**foundation
investigation and
design report**

BRAMPTON ESKER OUTLET EXTENSION
(in vicinity of Williams Parkway)

FOUNDATION INVESTIGATION REPORT

Brampton Esker Outlet Extension

TYPICAL TURNER DETAIL FOR 48" O.D. STEEL CASING

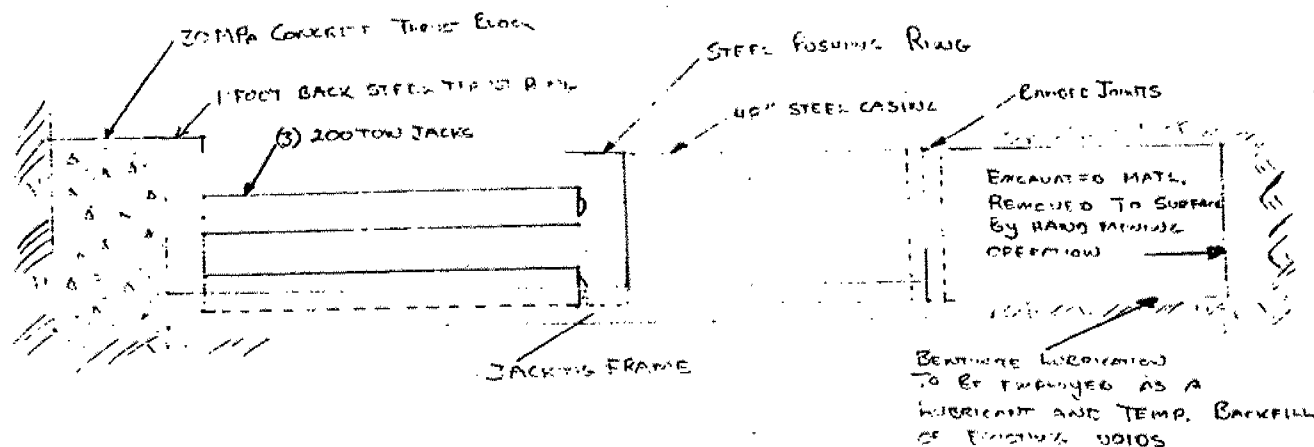
- 1) The success of the project is undoubtedly contingent on the groundwater conditions at the site and although it appears the contractor is aware of the potential soil behaviour in the tunnelling process, there is no convincing evidence of a planned scheme to mitigate damages that can result when fast ravelling and/or flowing ground conditions are confronted. These types of conditions, as stated in our original foundation report, occur when cohesionless soils such as the heterogeneous sand and gravel mixture (glacial till) and compact sand present at the proposed tunnel elevation are submerged within the prevailing groundwater table. The groundwater table at the time of the site investigation (87 01 09) ranged between about Elevation 227 m to 228 m, whilst the proposed tunnel invert elevation varies from approximately 227 to 227.5 m. However, groundwater tables tend to fluctuate with time and consequently, an established procedure should be planned that considers these unfavourable conditions and the potential ravelling that can result at the crown and excavated face of the tunnel. Loss of ground that may result from these sources and any unbalanced hydrostatic head that may develop can lead to settlements of the ramp and subsequent expensive maintenance. The methods described in JEGEL, namely advance jacking and/or forepoling may encounter uncontrollable resistance due to the denseness of the till deposit and the presence of cobbles and possible boulders within the deposit.

- 2) Due to the absence of drawings illustrating the proposed plan, the method of shaft construction is hereby unknown. The proposed scheme should comply with the recommendations provided in our original foundation report.

Further to your request, we have reviewed the geotechnical aspects of the proposed 1.2 m diameter drainage outlet (jacked concrete pipe sections), as shown on Drawing 1 provided by Armagh Contractors Ltd., and have made the following comments concerning the proposed method of construction, potential stability of the outlet crown and advancing face, and loads which the concrete pipe and any bulkhead must be designed to resist.

The proposed method of excavation, indicated by the contractor in Drawing 1, is considered to be acceptable given the relatively small outlet diameter and that the contractor appears to have recognized the potential ground behaviour. However, where running or flowing ground conditions occur, full or partial support of the tunnel crown and face will be required with possible dewatering to ensure safe and stable conditions. Support of the crown in difficult soils may be achieved by jacking the concrete pipe sections ahead of the excavated face and/or advance crown protection ("forepoling"). All pipe jacking and associated work must be performed in accordance with the Occupational Health and Safety Act and sound construction practice.
